Notice of Meeting
Polk City | Planning and Zoning Commission (P&Z)

SITE PLAN REVIEW

Project: Lakeside Fellowship Classroom Addition

Owner/ Applicant:	Lakeside Fellowship Church
Requested Action:	Approval of Site Plan Amendment
Location	1121 W. Bridge Road North of Bridge Road
Size:	8.50 acres
Zoning:	C-2 Commercial
Proposed Use:	Religious Institution

1 SOUTH ELEVATION W/ PHASE 3 ADDITION
SCALE: 1/8" = 1'-0"

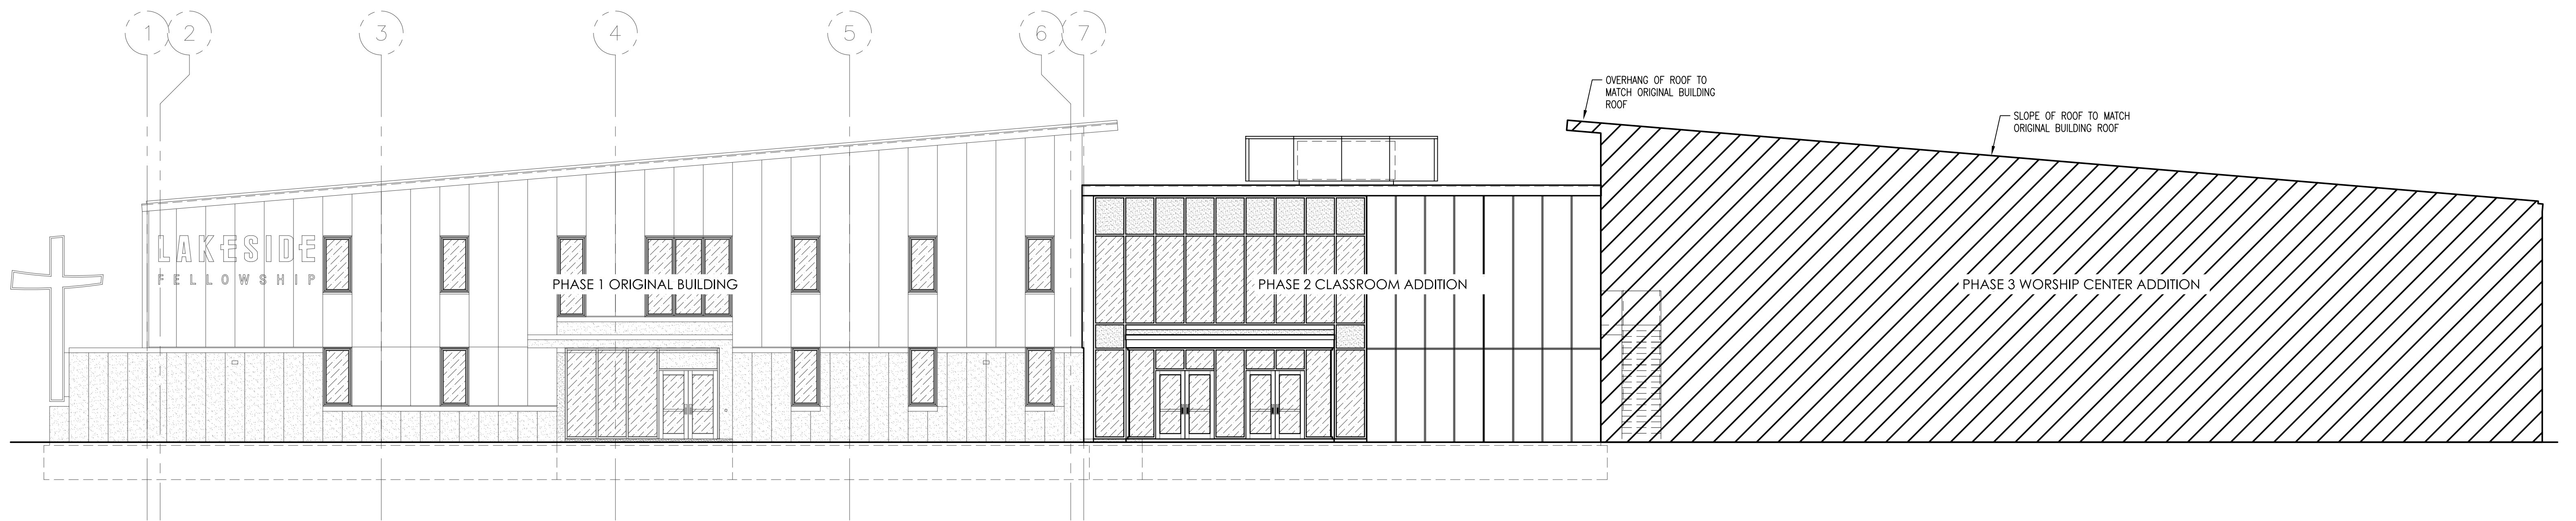
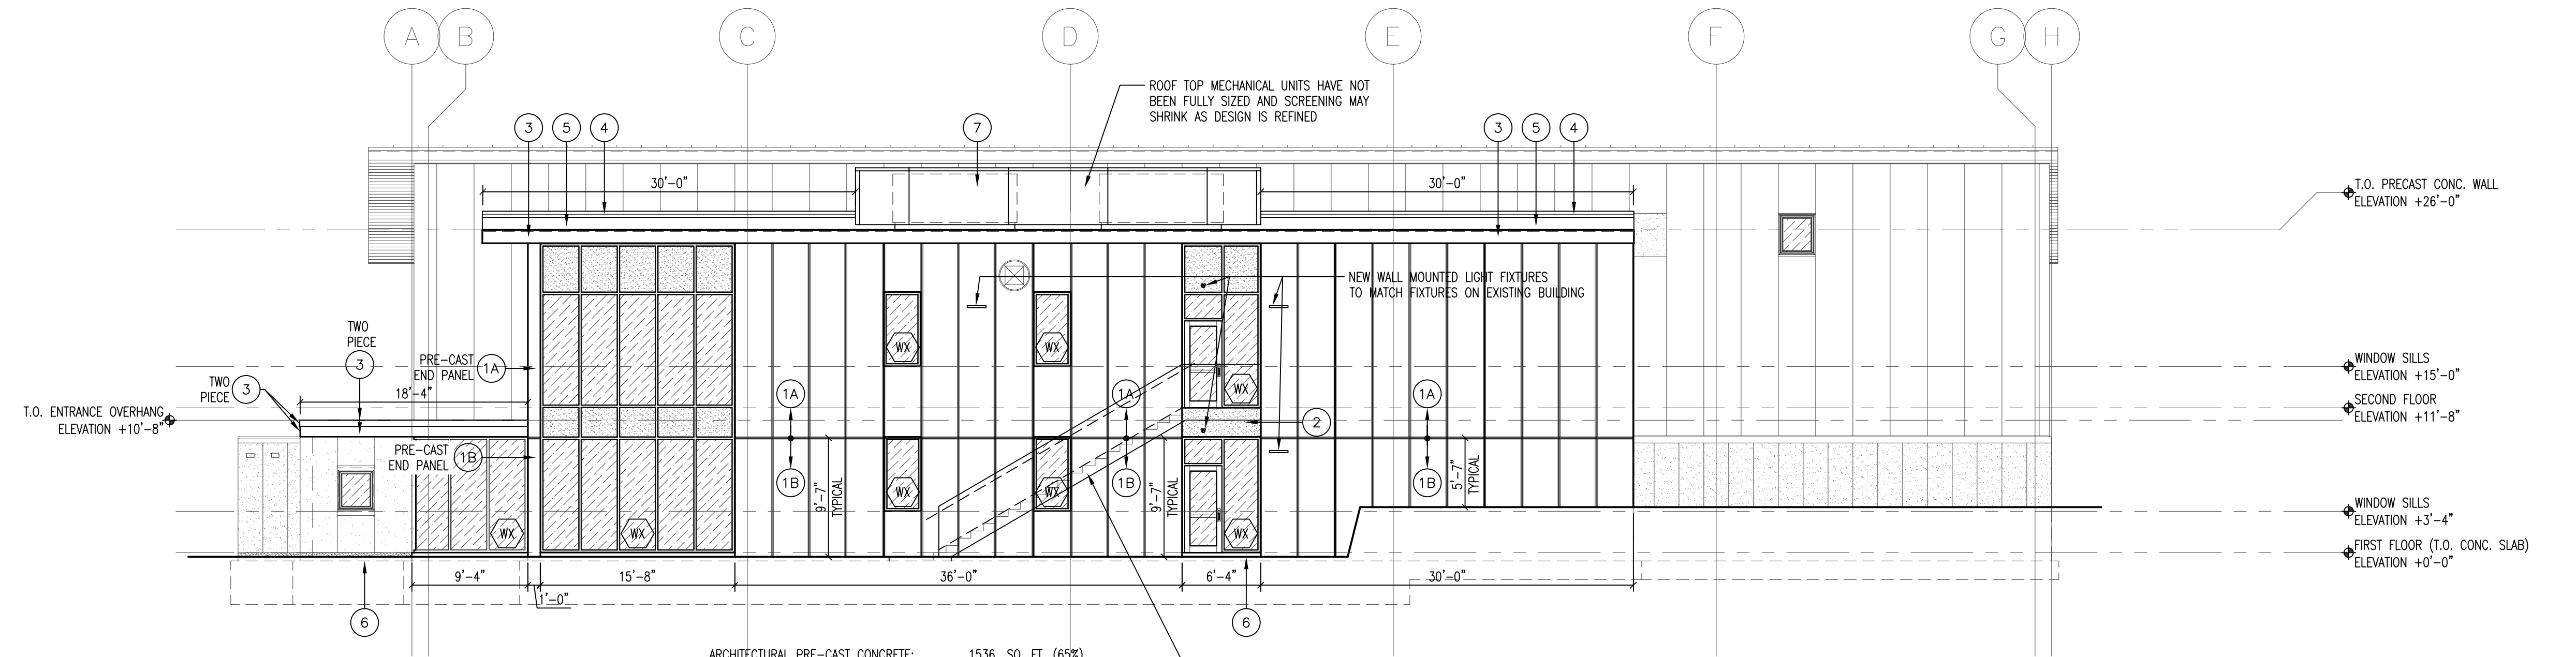
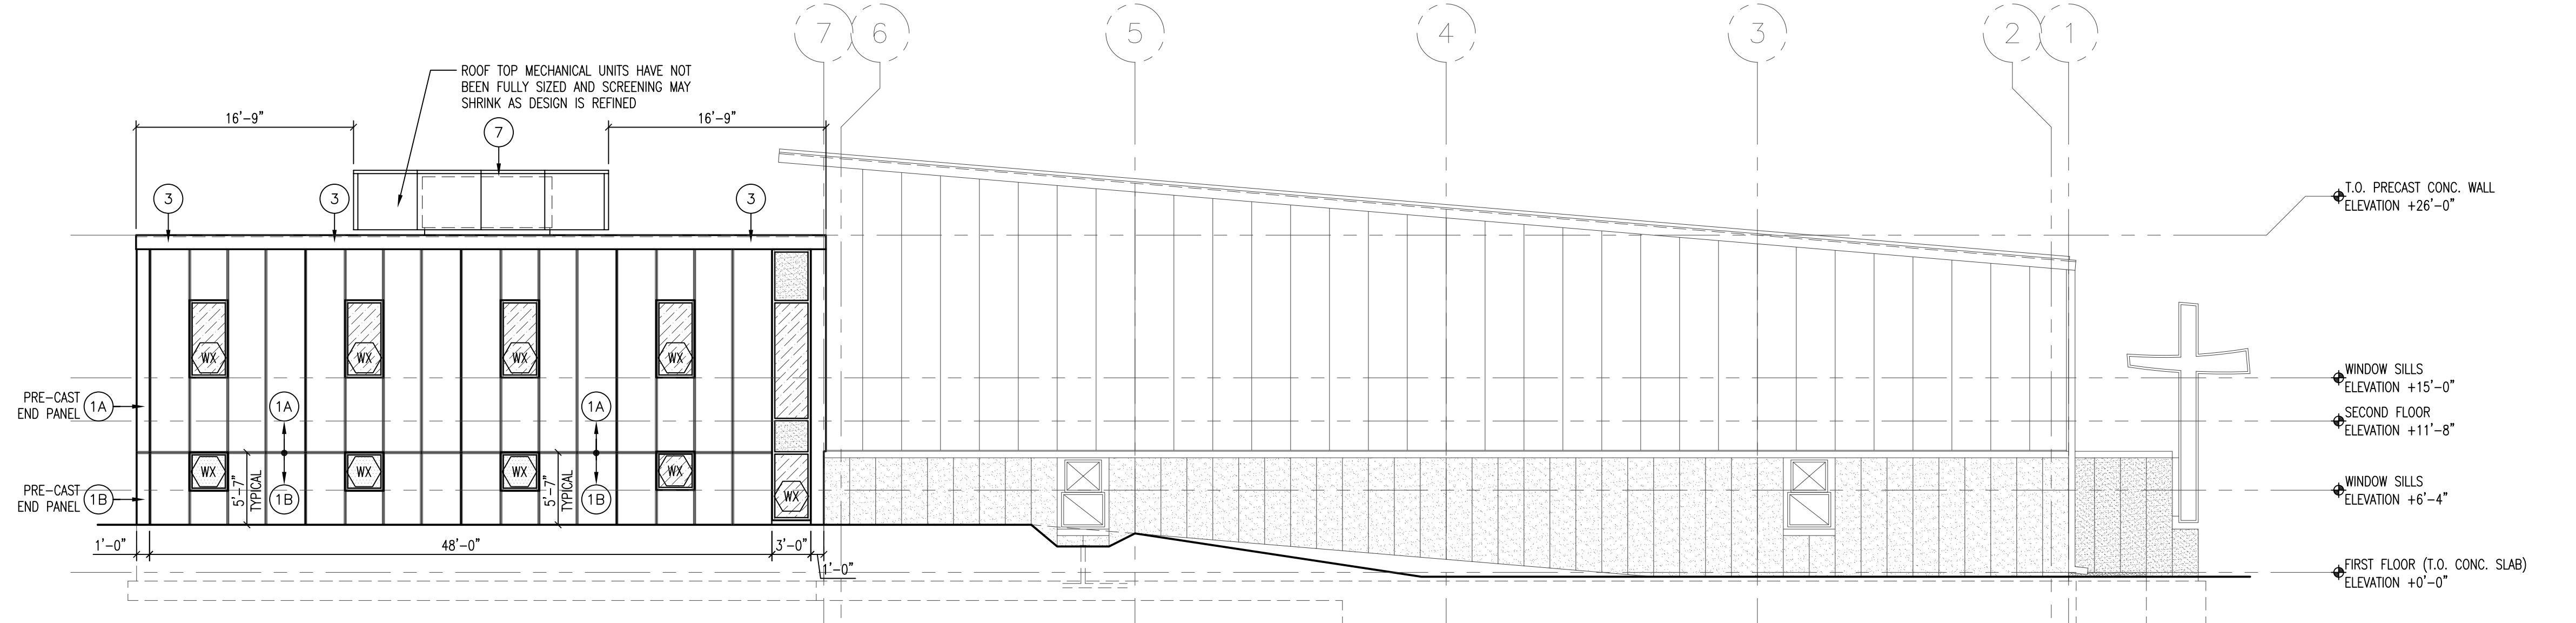
1. Per 157.09-2C, pitched roofs with gables, hips, dormers and similar offsetting and intersecting roof lines are desirable for increased architectural character. As presented when the Original Site Plan was approved, the building was designed with a single pitch slope, however the future building addition was to have a single-pitch roof in the opposite direction for increased architectural interest. The current building addition is proposed to have a flat roof however, the applicant has included an architectural elevation showing their intent for the Phase 3 worship center addition to include an opposite pitched roof as future construction.

2. Per 157.09-5E, screening shall be provided for roof-mounted HVAC units to conceal such units from public view and adjacent residential areas. This project abuts Edgewater Drive which, near Roosevelt Street, sits approximately 10 feet higher than the finished floor of both

the existing building and addition which may increase the prominence of these rooftop units. The property owner is currently proposing a flat, acrylic screening product that wraps around the rooftop HVAC units in a color that matches the architectural intent of the rest of the existing and proposed building structure. Typically, buildings of this nature include a parapet wall across the entire width of the structure to provide screening and avoid drawing attention to the roof mounted HVAC systems they are screening. Staff requests the applicant consider extending the acrylic screen farther west so that it ties into the existing structure. When the Phase 3 addition is constructed, the acrylic screen could be extended to the east to tie into that future structure.

3. As discussed as part of the original site plan, the exterior, east stairway, which will be relocated as part of this project, was to be constructed in such a manner that is better concealed from the public view.
